RS-06-109

August 18, 2006

Subject: Response to Request for Additional Information Regarding Application for Steam Generator Tube Integrity Technical Specification

Response to Request for Additional Information Regarding Application for Steam Generator Tube Integrity Technical Specification Change

Figure 4: Sketch of Cracked Tube in Tubesheet leading to Leakage Flow-rate, Q_{OUT}. (Note that the gap shown between the tube and the tubesheet is for illustration purposes only.)

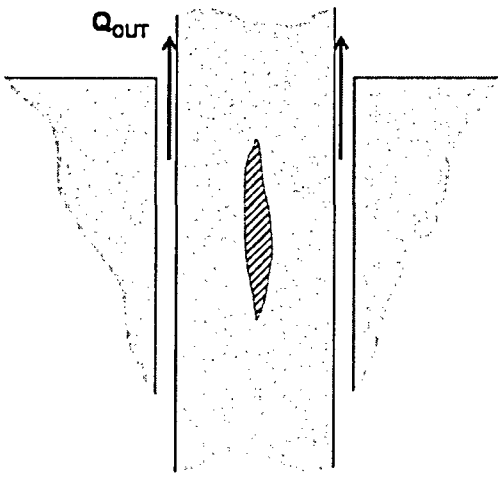
Response 5:

In trying to use the Westinghouse computer model to provide a qualitative demonstration of the veracity of the B* analysis, a significant potential shortcoming associated with the approach must be recognized. The crack flow leak rate model portion of the code was based on a freespan axial crack, not a crack with flanks constrained by the tubesheet hole. Thus, the crack opening area computation could be significantly biased. In order to perform the requested studies the code was modified as follows:

The new model for the axial crack opening that takes into account the guidance and constraint provided by the surrounding tubesheet is described in what follows. See Figure 1, below, for a sketch of the model configuration.

Figure 1: SLB design pressure change history.

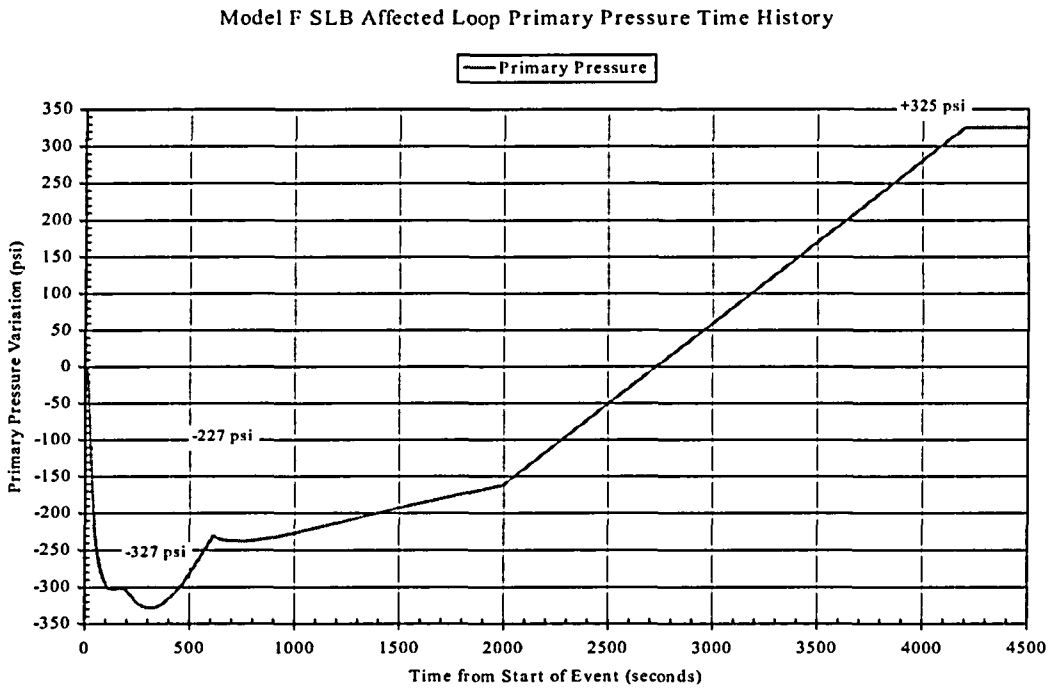
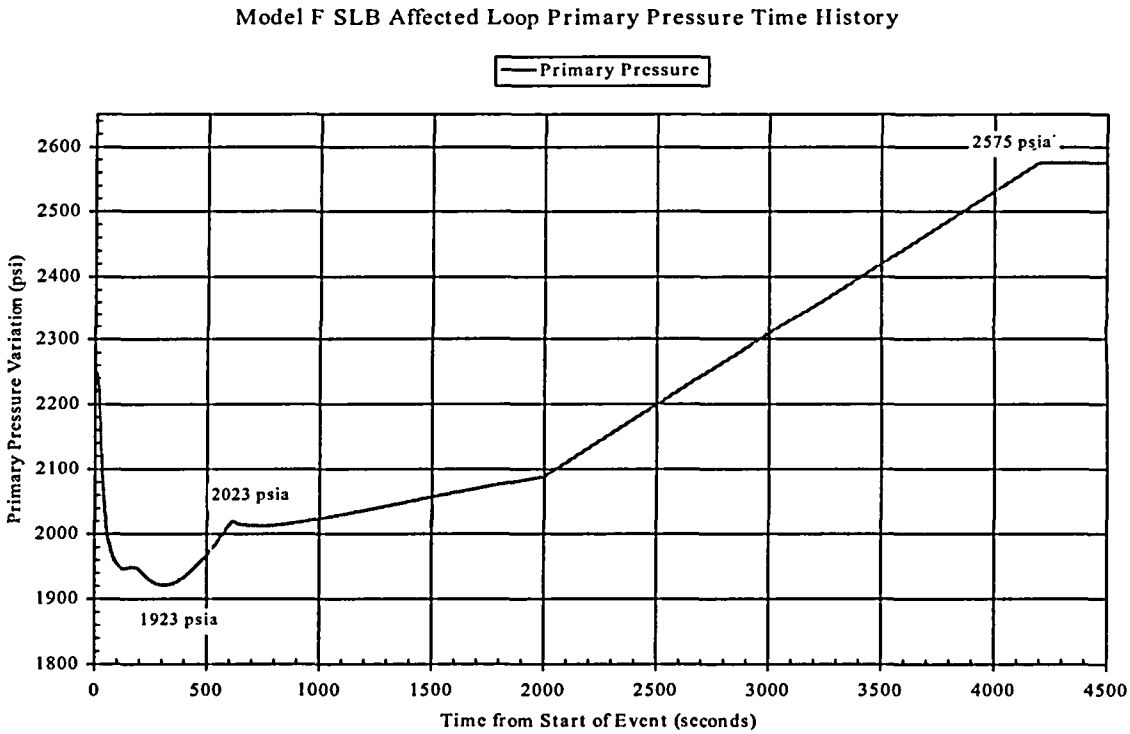
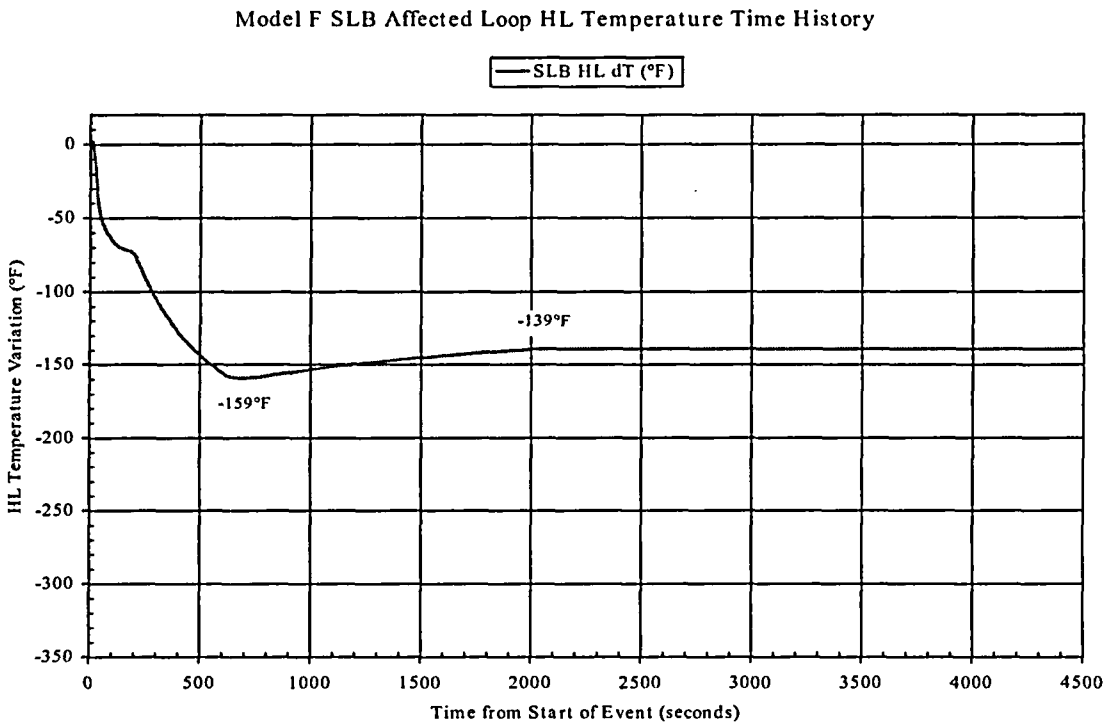
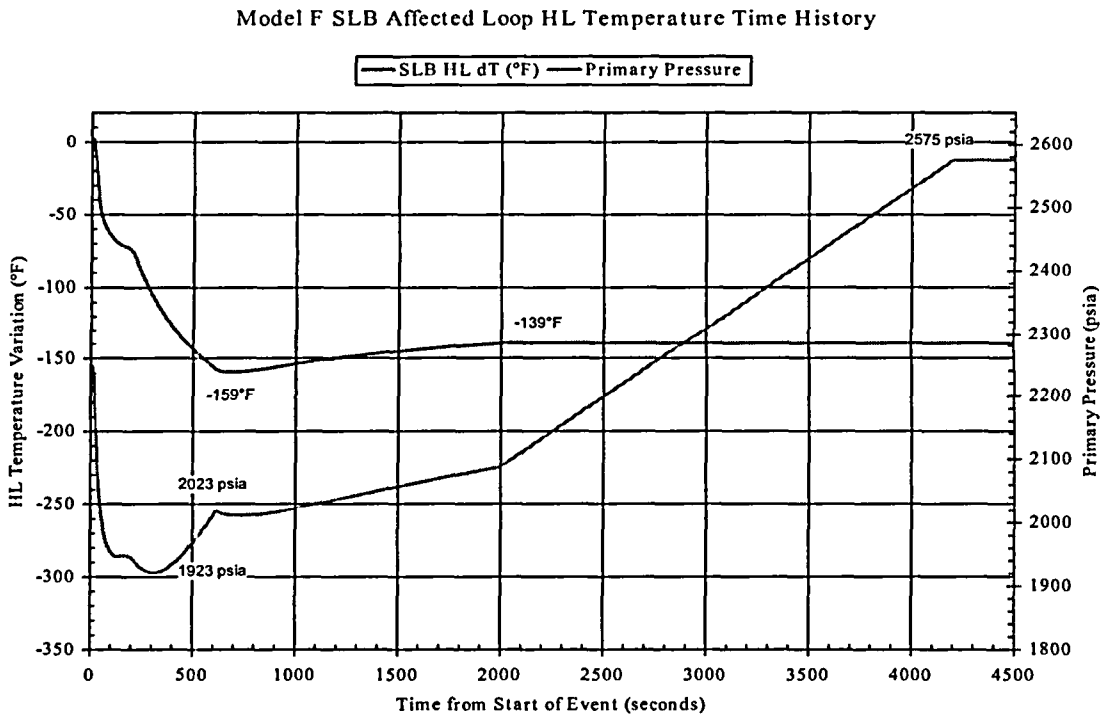
NRC RAI 6: The bellweather principle maintains that the increase in primary to secondary leakage when going from normal operating to accident conditions is bounded by a factor of 2. This is based, in part, on an assumed main steam line break (MSLB) and feed line break (MFLB) pressure differential of 2560 and 2650 psi, respectively, and a temperature of 600 degrees F. Provide the rationale which supports the conservatism of the 600 degree F assumption. This rationale should consider the time history of primary and secondary pressure and temperature during the accident. The staff's purpose in asking this question is ensure the time integrated leak rate is bounded by the bellweather principle factor of 2 increase relative to normal operating leakage. Provide the primary pressure and temperature curves as a function of time for the MSLB and MFLB accidents under consideration. Also, provide the rationale supporting the conservatism of the bellweather principle for a large break loss of coolant accident.

The calculation of the leak rate during a postulated SLB event is not based on a temperature of 600°F, but on the temperature obtained from an examination of the equipment specification curves for the transient. In addition, the calculation of conditions during normal operation is based on a set of umbrella values resulting in considering primary fluid temperatures of 604.3 and 621.4°F for secondary side pressures of 782 and 947 psig respectively. Both conditions are used.
The SLB transient is assumed to initiate while the plant is at hot standby conditions, i.e., 557°F. The primary temperature drop is 139°F leading to an analysis temperature of 418°F. The secondary temperature drop is 307°F leading to a shell temperature of 260° for the analysis. The design specification pressure changes are illustrated on Figure 1 and the actual pressures for Seabrook are shown on Figure 2. The design specification temperature history during a postulated SLB event is shown on Figure 3. The superposed curves are shown on Figure 4. It is readily seen that the most limiting differential pressure, 2575 psi, occurs when the temperature is at a relatively steady state for both the hot and cold legs. The analyses were performed for the conditions at about 600 seconds into the transient and found to be less limiting than when the pressure difference is at a maximum. The H* engagement length required to resist the SLB differential pressure with a margin of 1.4 is about 0.15 inch greater for the latter condition. The B* length to restrict the SLB leak rate to a factor of 2 relative to that during NOp, based on the method of calculation, is about 7% longer for the conditions at 4200 seconds relative to those at 600 seconds. Examination of Figure 4 leads to the conclusion that the differential pressure is the controlling factor and the value at 4200 seconds will bound any value in between the two.
